## Addendum #1

**Project Name:** Randolph Elementary Additions & Renovation  
1024 S. 37<sup>th</sup> Street  
Lincoln, Nebraska 68510

**SHA Project No.:** 15049-05  
**LPS Bid No.:** 8366  
**Date Issued:** February 3, 2016

Revision to Detail: **A5/A102A**

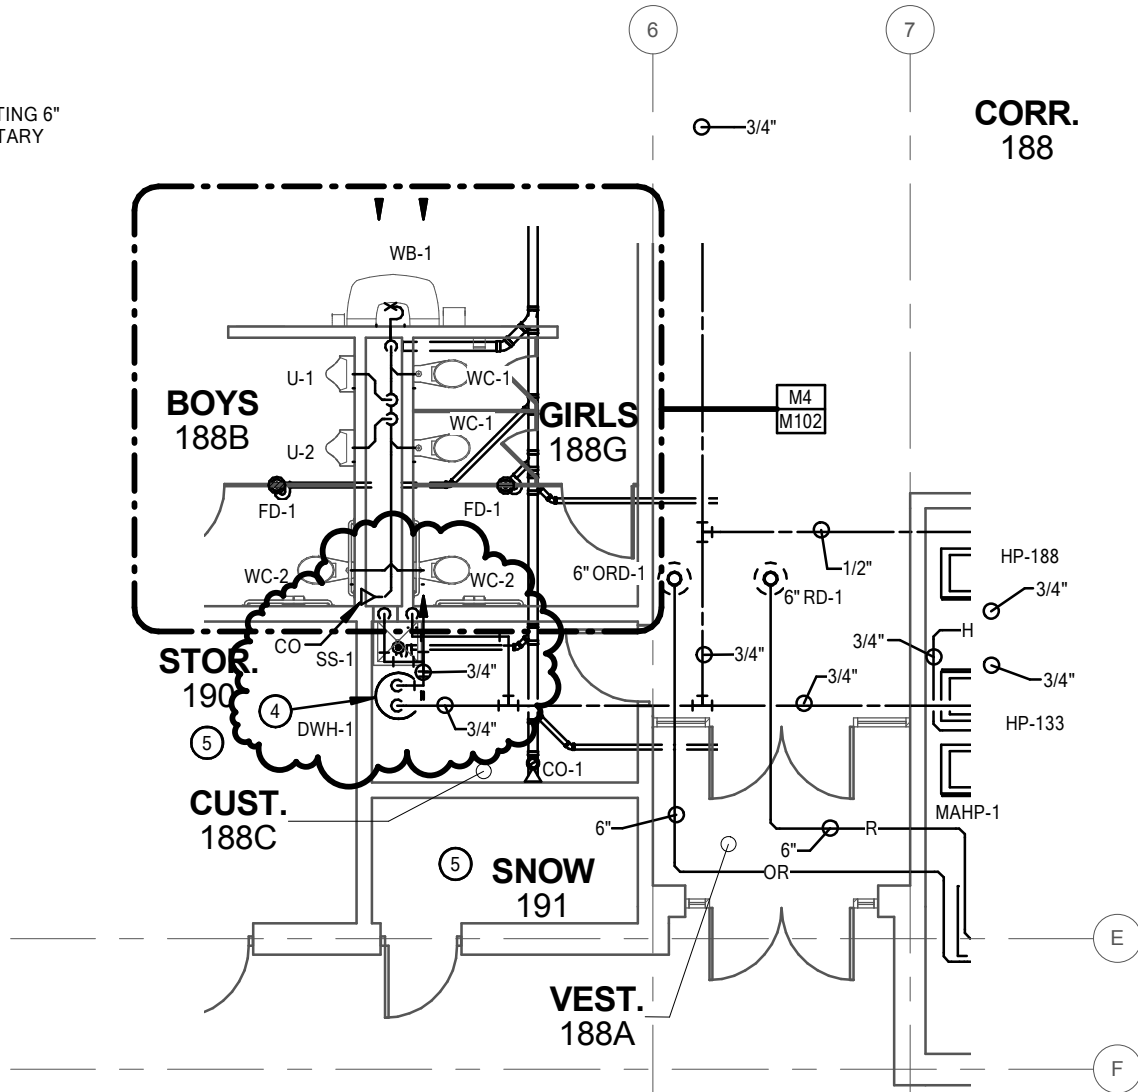
**ADD 1-3.** Refer to Sheet A102A, Detail A5; The background plan indicates a solid wall that separates Corridor 286 from Corridor 280 to the south. No wall exists. Refer to **Attachment A1** for further clarification of existing conditions.

# 1 FIRST FLOOR PLUMBING PLAN - AREA "B"

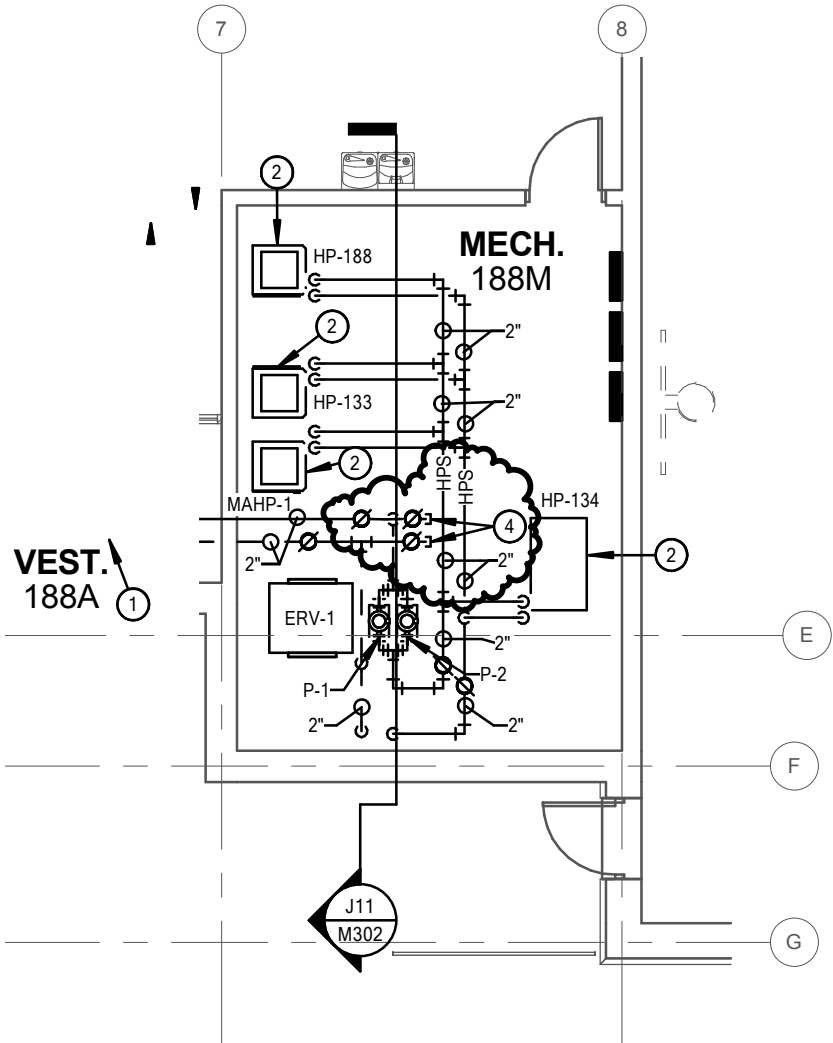
- ADD 1-5.** Refer to Sheet M102, Detail A1, First Floor Plumbing Plan – Area “B”; Modify location of service sink located in Custodial 188C as indicated on **Attachment M102-1**.

# 1 FIRST FLOOR HYDRONIC PLAN - AREA "B"

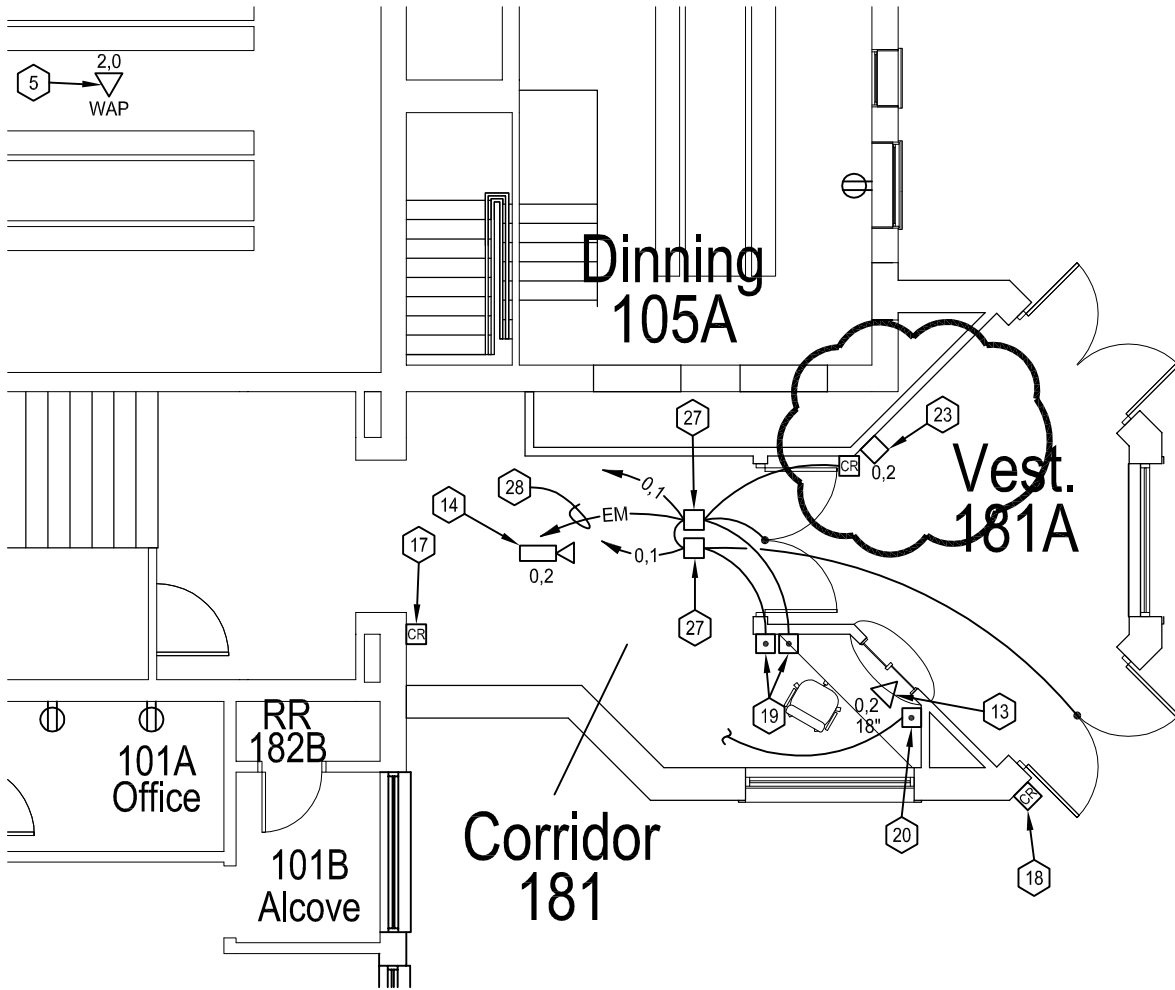
- ADD 1-6.** Refer to Sheet M200, Detail A1, First Floor Hydronic Plan – Area “B”; Add ball valves and blind flange as shown on **Attachment M200-1**. Add Sheet Note 4 which shall read as follows:

4. PROVIDE 2” BALL VALVE AND BLIND FLANGE FOR VENT AND SYSTEM FILL.
- ADD 1-7.** Refer to Sheet T1.1A, Detail A1, First Floor Telecommunication Plan – Area “A”; At Vestibule 181A, add device and Note 23 as indicated on **Attachment T1.1A-T1**.

4 PROVIDE 2" BALL VALVE AND BLIND FLANGE FOR VENT AND SYSTEM FILL.
